SUBSURFACE WASTEWATER DISPOSAL SYSTEM APPLICATION

Town Or Plantation: AUGUSTA

NEW SYSTEM VARIANCE REQUEST

Subject: New System Variance approval, Grenier property, West River Road,
Augusta

SUBSURFACE WASTEWATER DISPOSAL PLAN

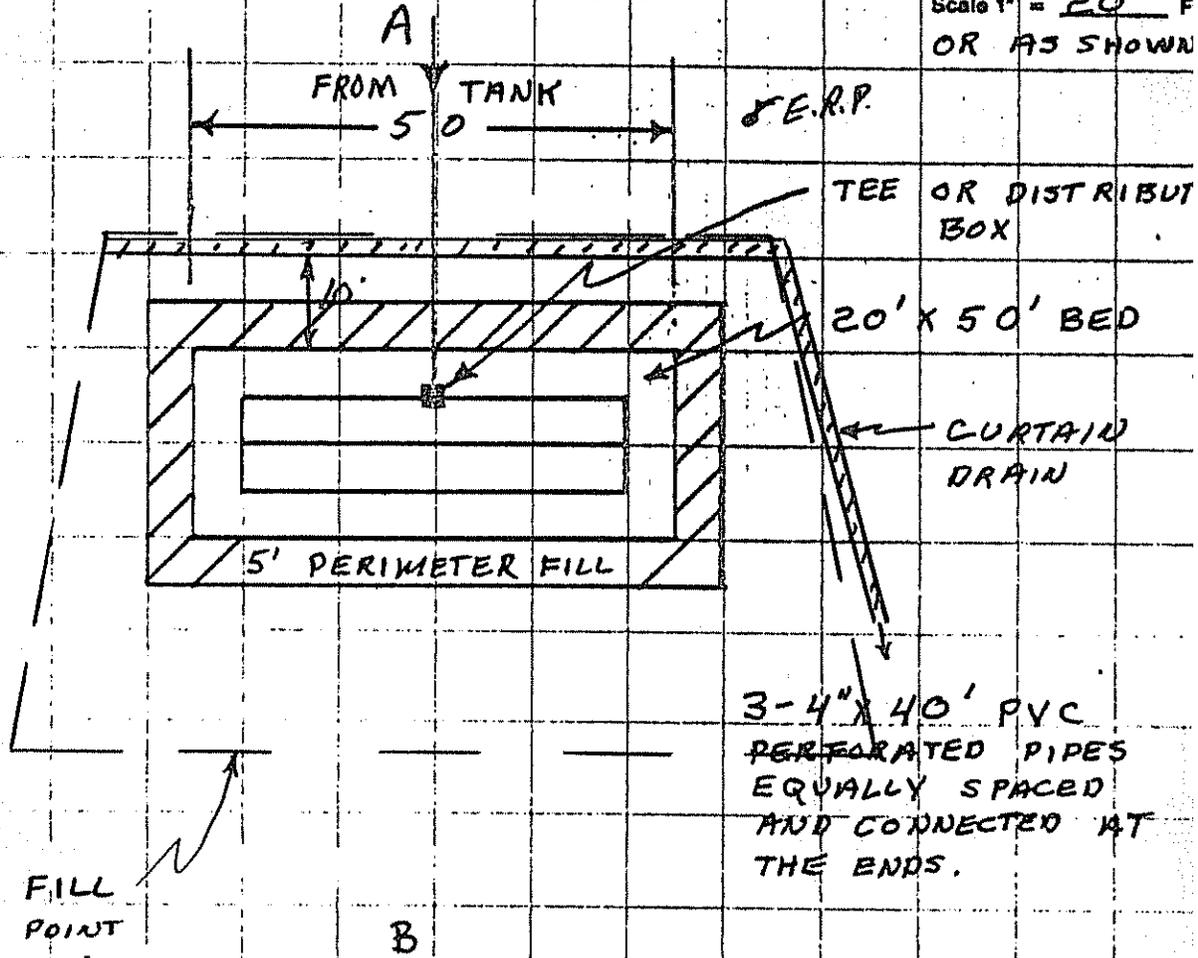
To allow a disposal system to be installed on soils that do not meet the minimum criteria. Specifically, the seasonal high groundwater table is located 13 inches below grade.

The Division approves of the application dated April 18, 1987 by William W. Rideout, SE.

Mr. Rideout shall be retained to establish the system location and elevation at the time of construction.

Gary R. Fuller, the Local Plumbing Inspector shall issue a permit prior to the system's installation. The system shall be constructed in compliance with the submitted application.
